PRODUCT CHANGE NOTICE PCN Form (D4-E000-73)

EOL/PCN#22-007

Existing Model:	Replacement Model:
RBP-650+	RBP-650A+

REPLACEMENT PART REFERENCE GUIDE, RBP-650+

MECHANICAL DIMENSIONS

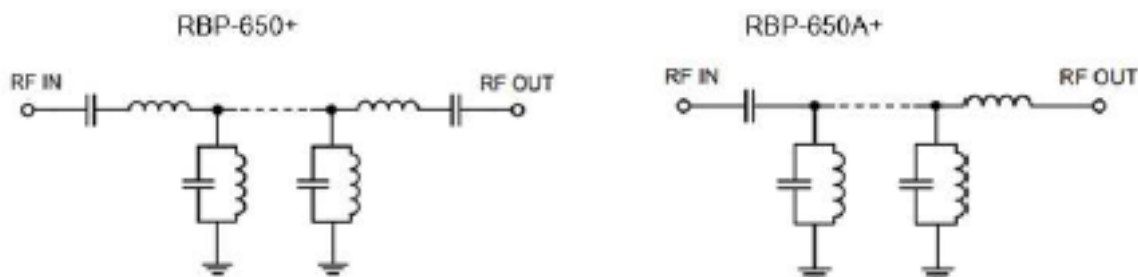
Case Style: GP731
Replacement part uses same case style as original part.

Original Part: RBP-650+

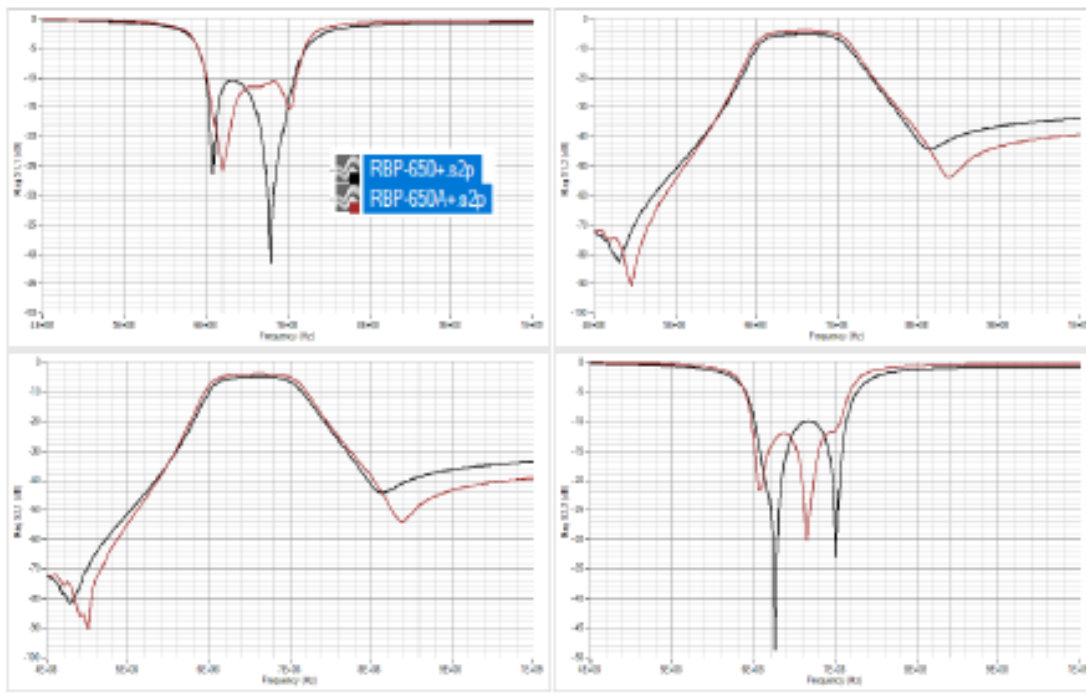
There is minor change in Function (Performance) due to change in functional schematic.

3) TYPICAL PERFORMANCE GRAPHS AT ROOM TEMPERATURE:
